Project: Stiltsville Fish Bar
1787 Purdy Ave.
Miami Beach, FL 33139

Please find responses in reference to Comments BDRB20-0548

Final/ Formal Submittal
Letter of Intent for Design Review Board
Application DRB20-0548 (fka 23220)
Stiltsville Fish Bar, 1787 Purdy Avenue
Miami Beach, FL 33139

ROOF DECK ADDITION

**Proposed
FAR Information**

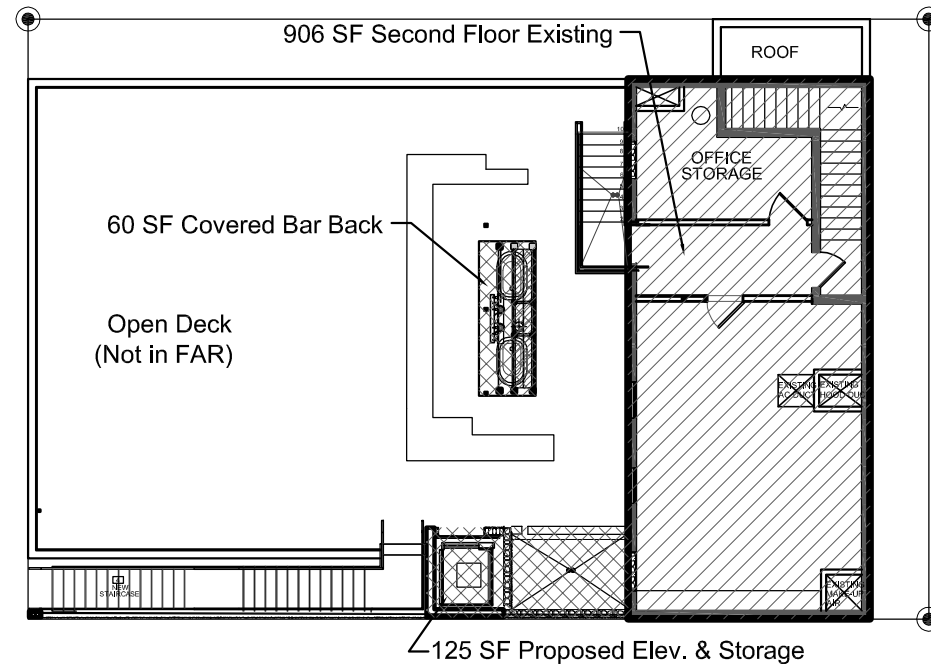
1. Narrative response added.
2. Zoning FAR updated and rechecked. I have 40sf more than you calculated but very close.
3. Fees will be paid 5/18/20. I would like to review those fees this week, thank you.
4. I will upload to CSS Formal Submittal; I did not find a Novus Formal Submittal Format Standard. We understand no changes can be made. Thank you.

- iv. Deliveries & Garbage are to use the same valet parking during morning hours.
3. Plans simplified and corrected to show Existing and Proposed.
 4. FAR recalculated.

Proposed Floor Plans
Second Floor

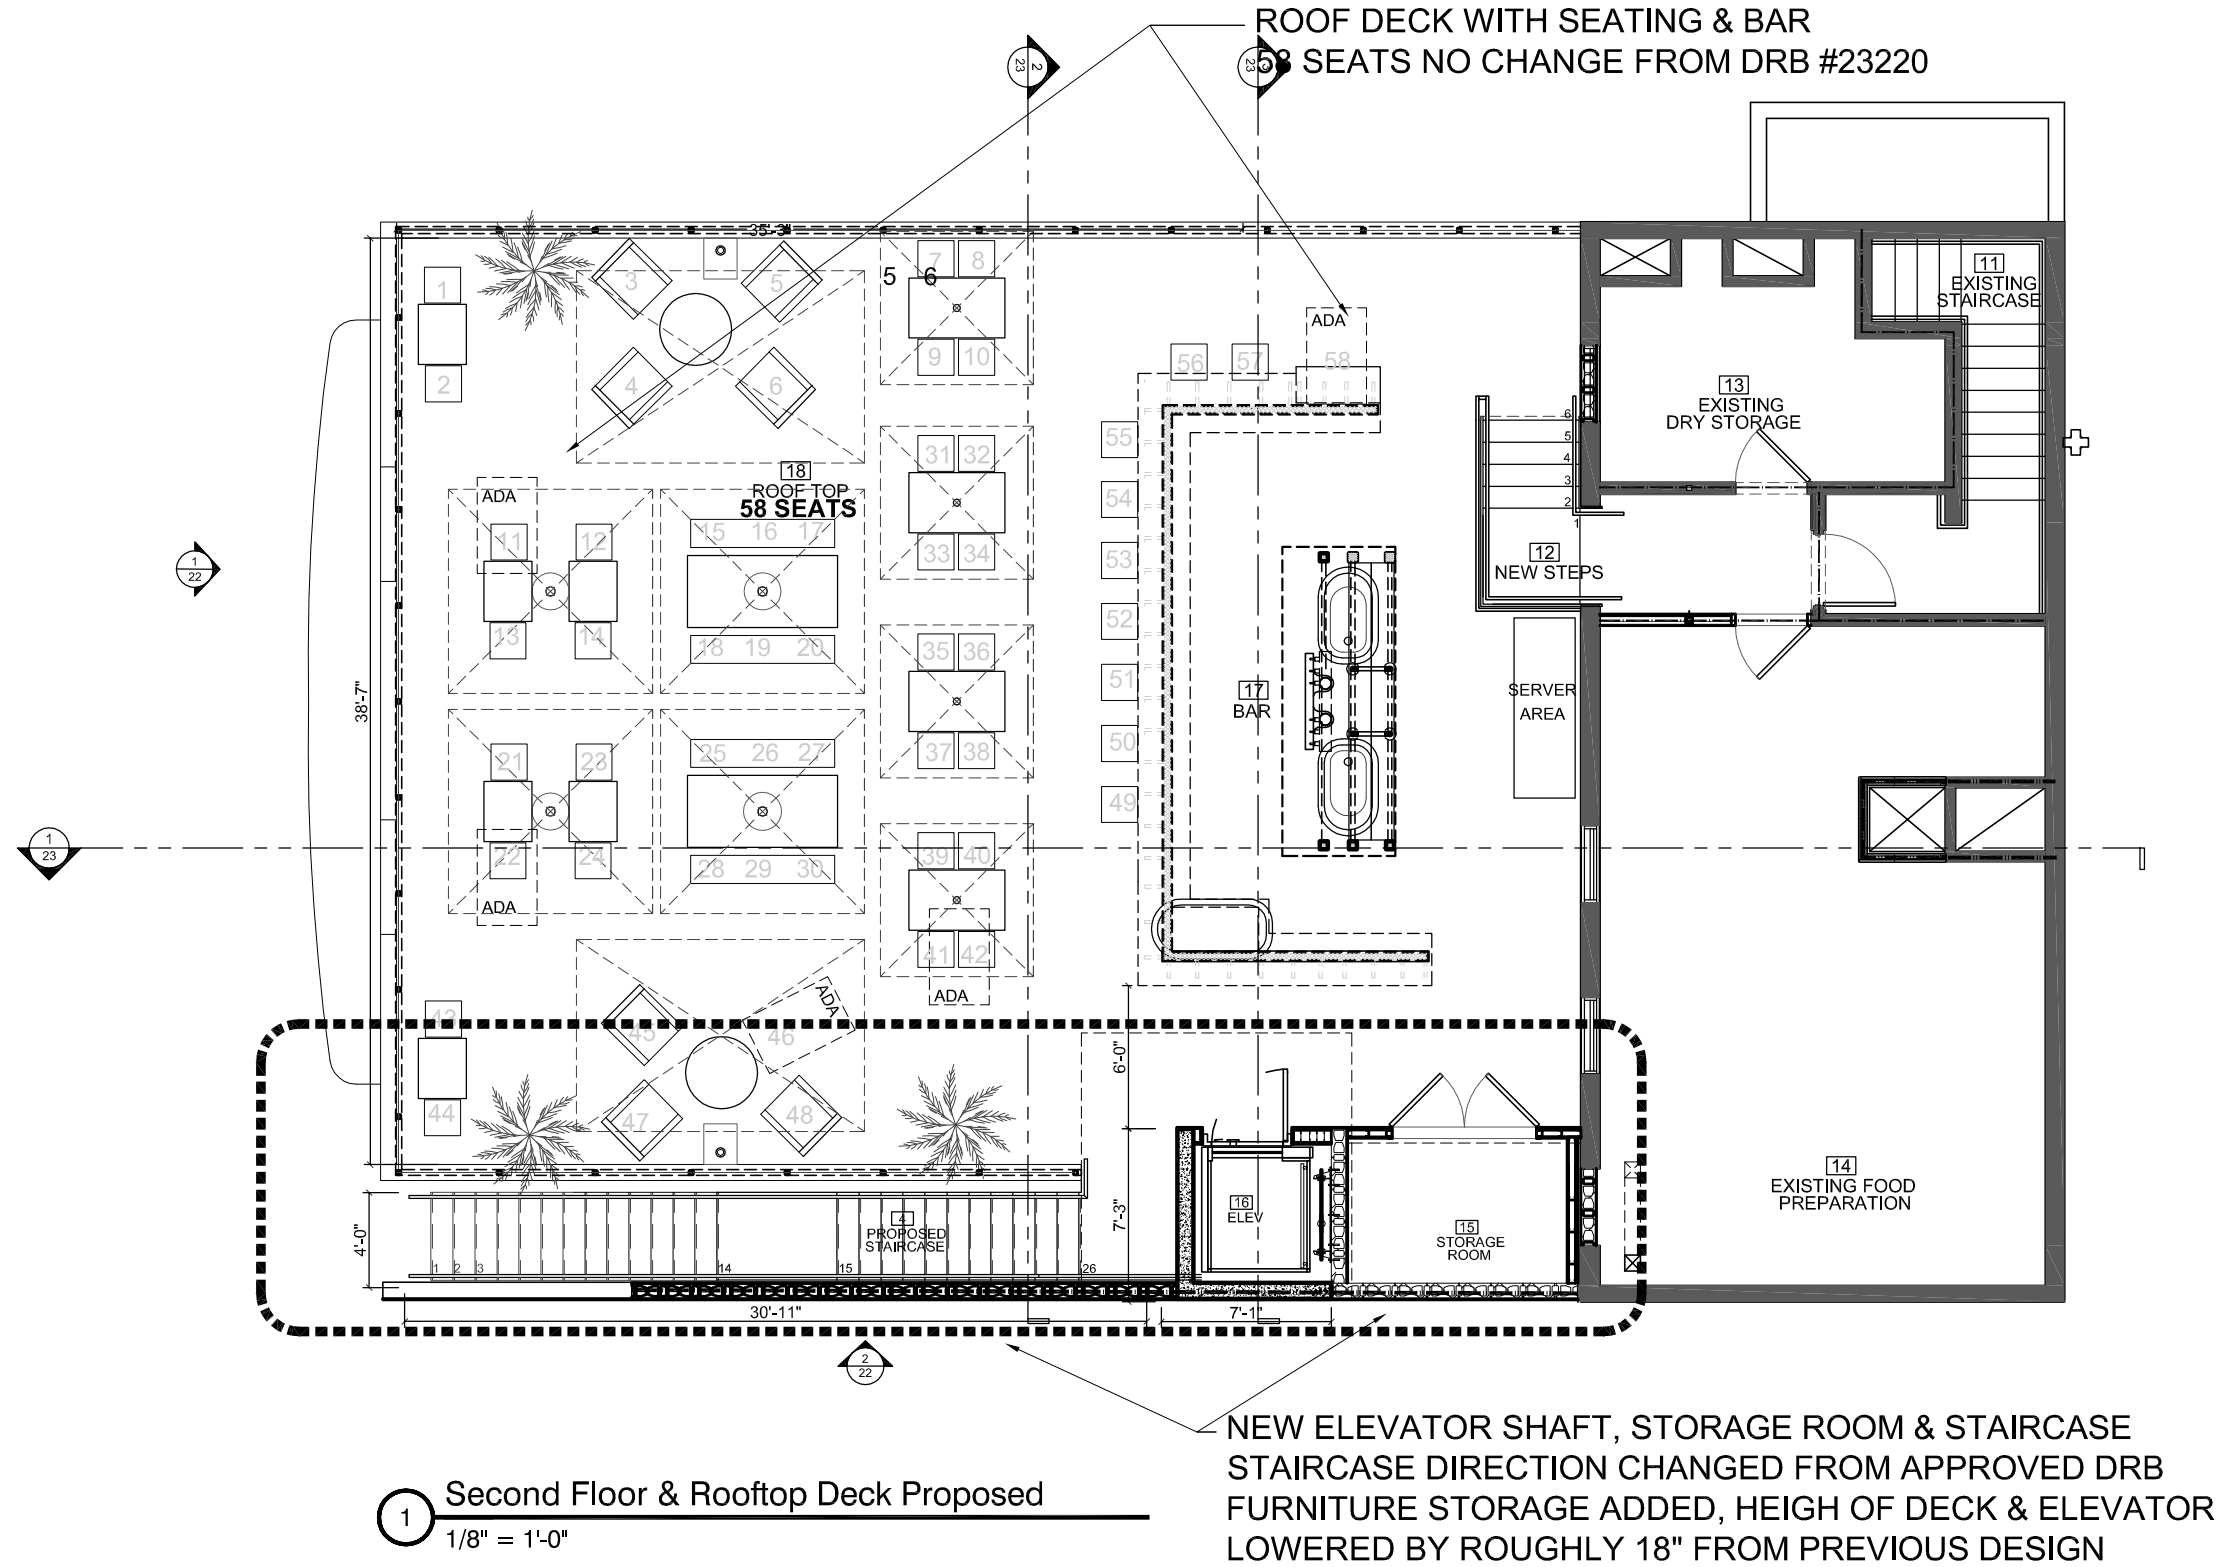
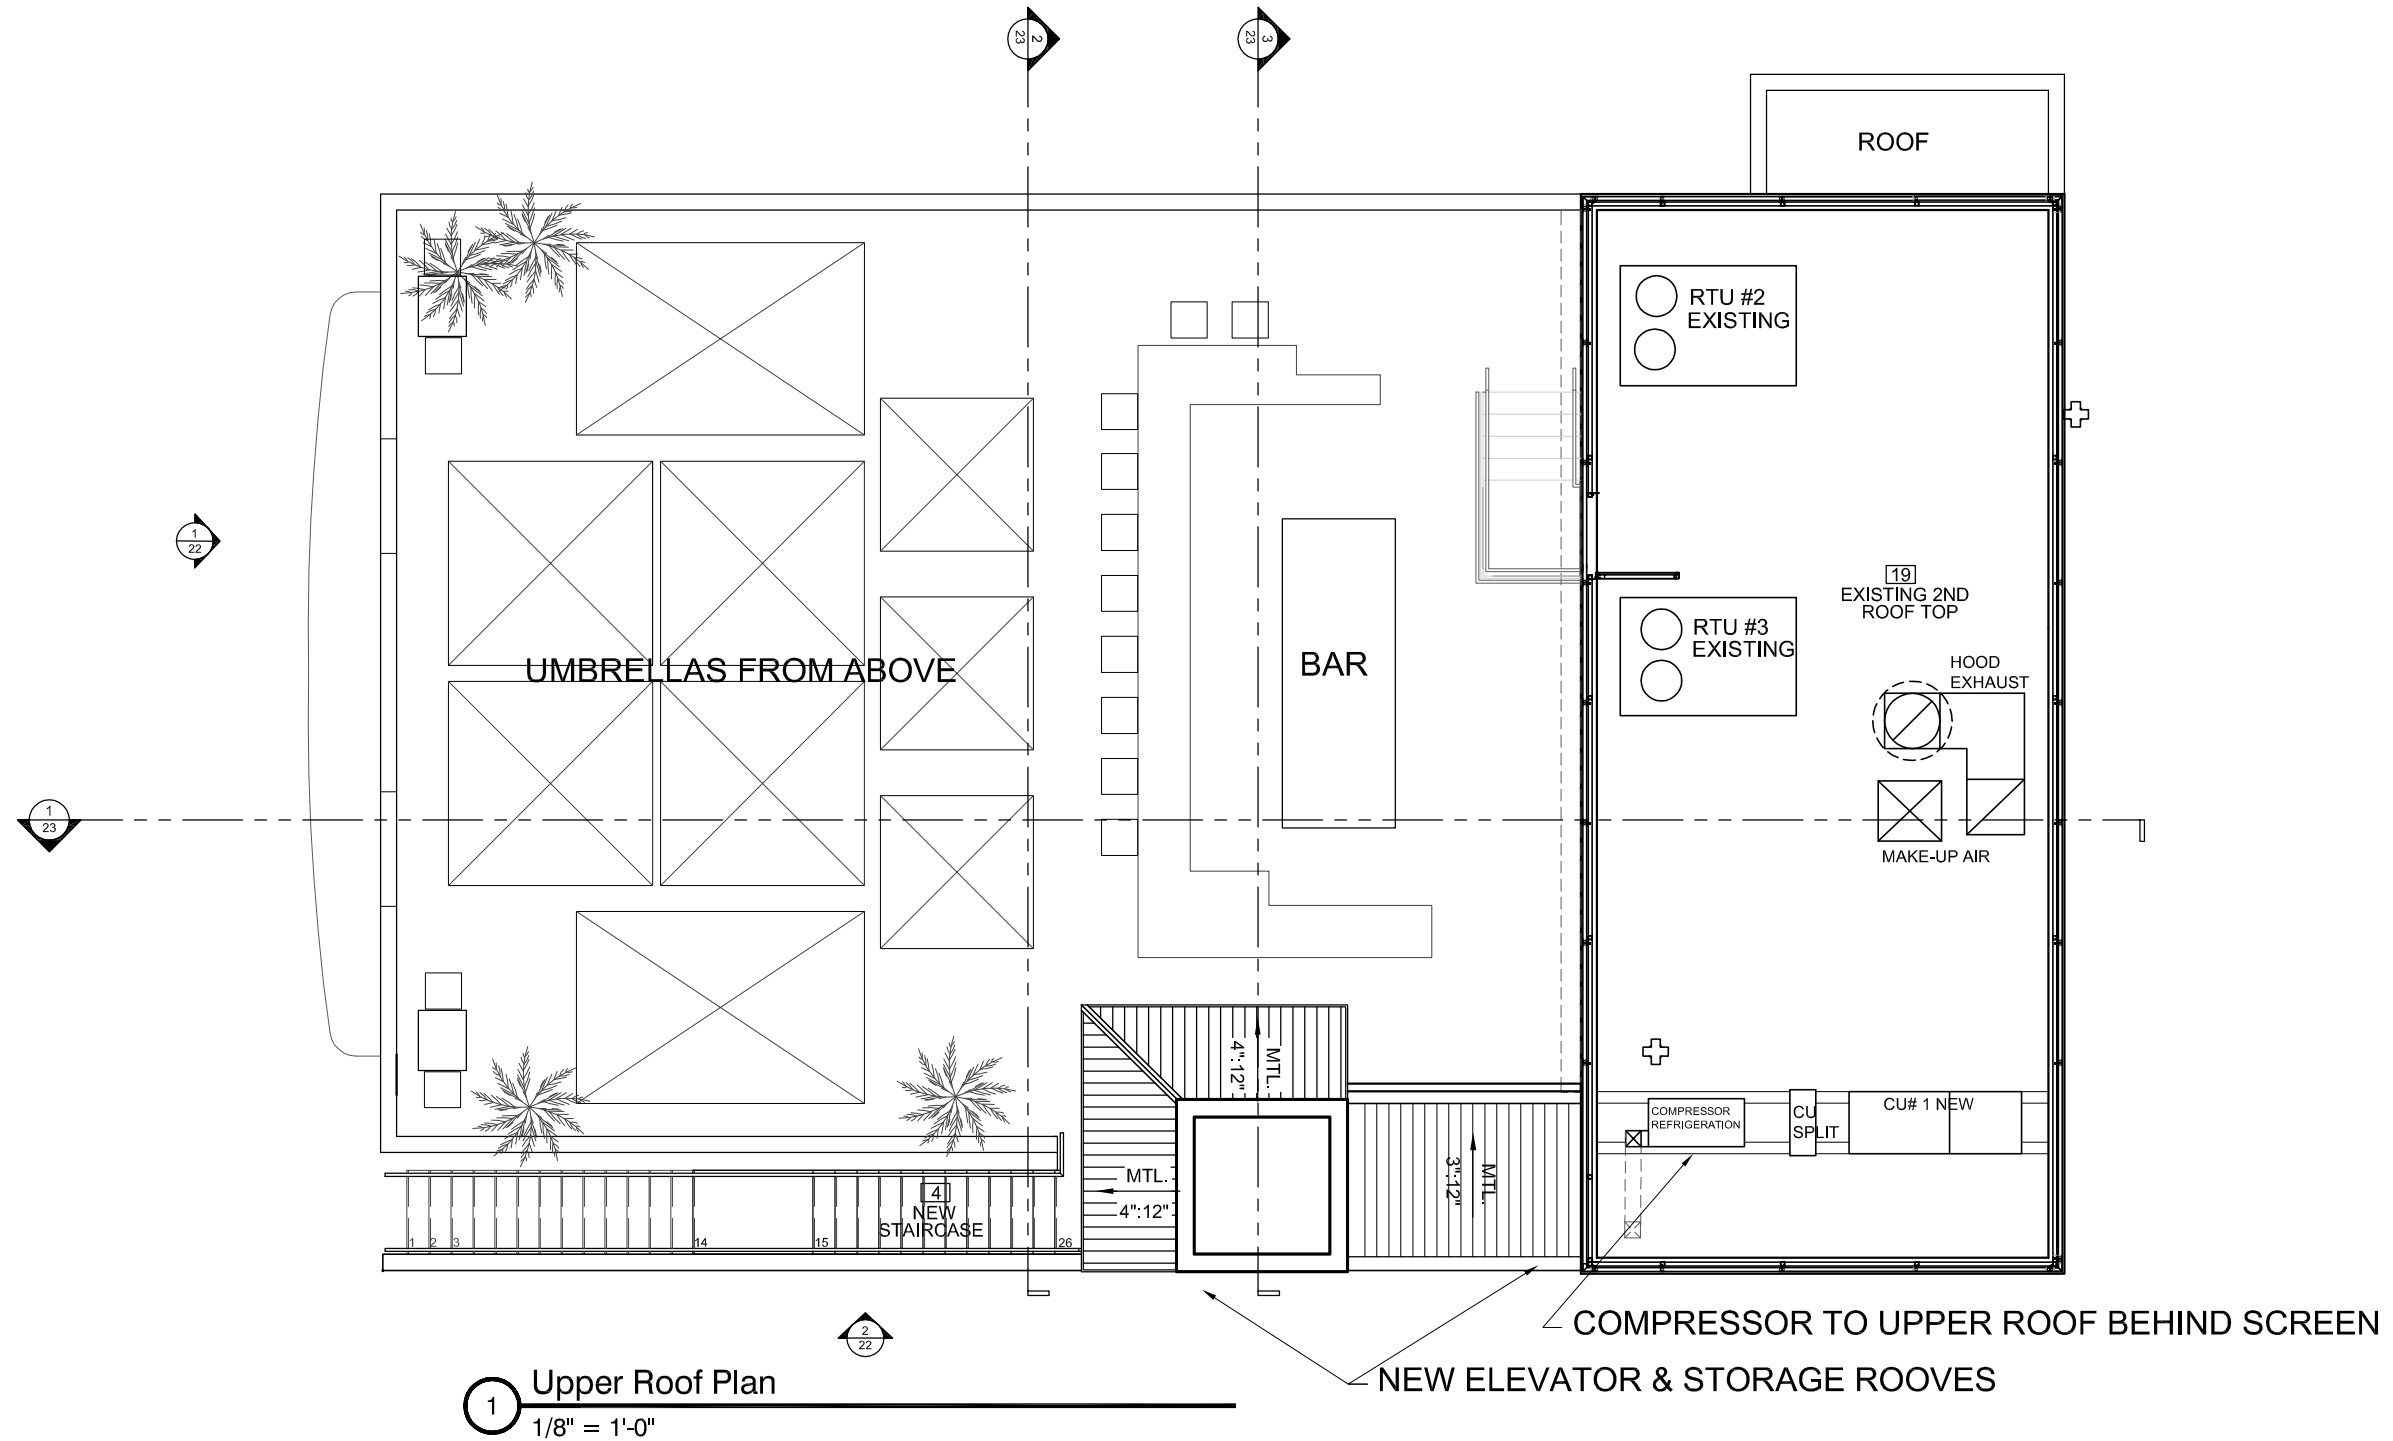
II) PROPOSED REVISIONS: The Applicant now intends to complete the originally proposed rooftop improvements, with several minor modifications to the design to make the work feasible. The Applicant is proposing to: (1) redirect the staircase from the approved design (through the building to the roof deck) to an alternate design accessing directly from lower sidewalk level to the roof deck and; (2) remove the approved retractable awning and replace with standard City-approved umbrellas covering customer tables – the remainder of the second floor dining area will be open to the sky.

- i. Deletion of Redundant Notes
 - ii. Deletion of required through building primary staircase.
 - iii. Changing Awning to Umbrellas in CUP order.
 - iv. Drawing Simplified to show Rooftop Addition, Stair, and Seating

1 Proposed Front Elevation (west)
1/8" = 1'-0"

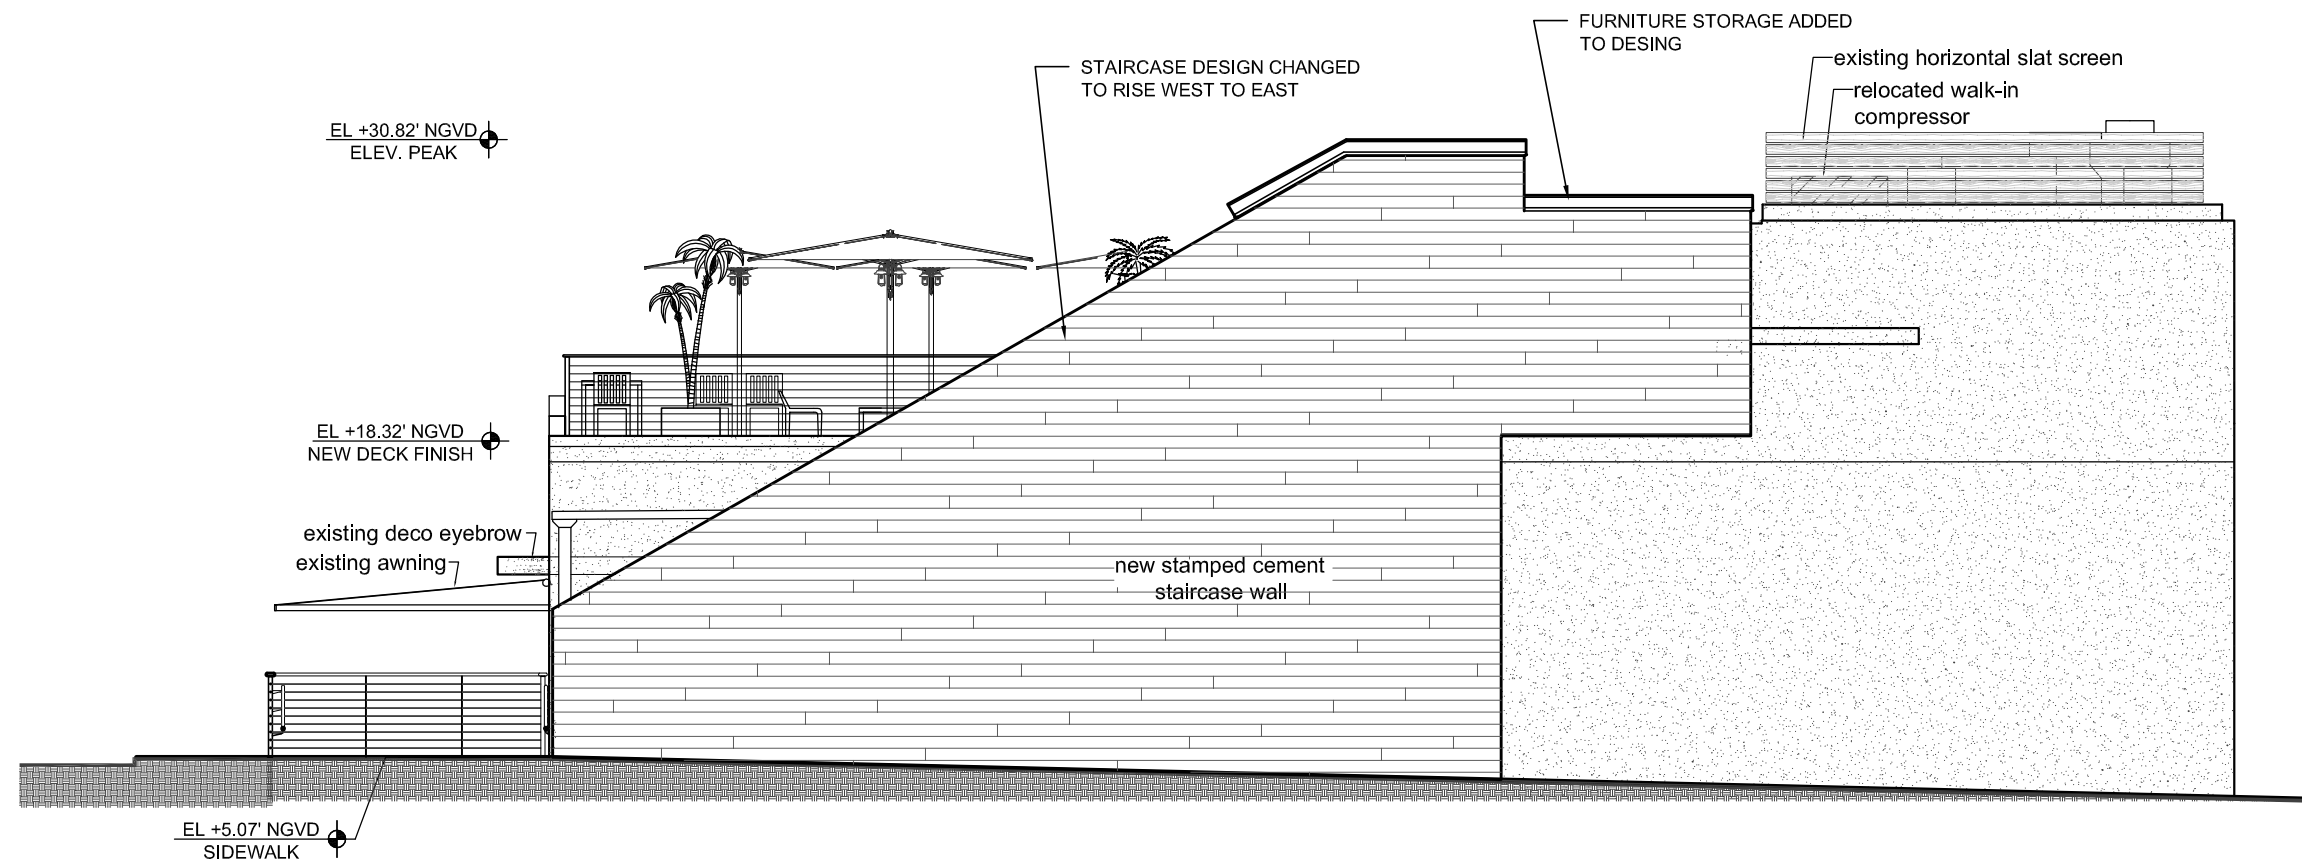
- k. Rendering Updated to reflect staircase direction.
 - l. Lighting Plan Updated
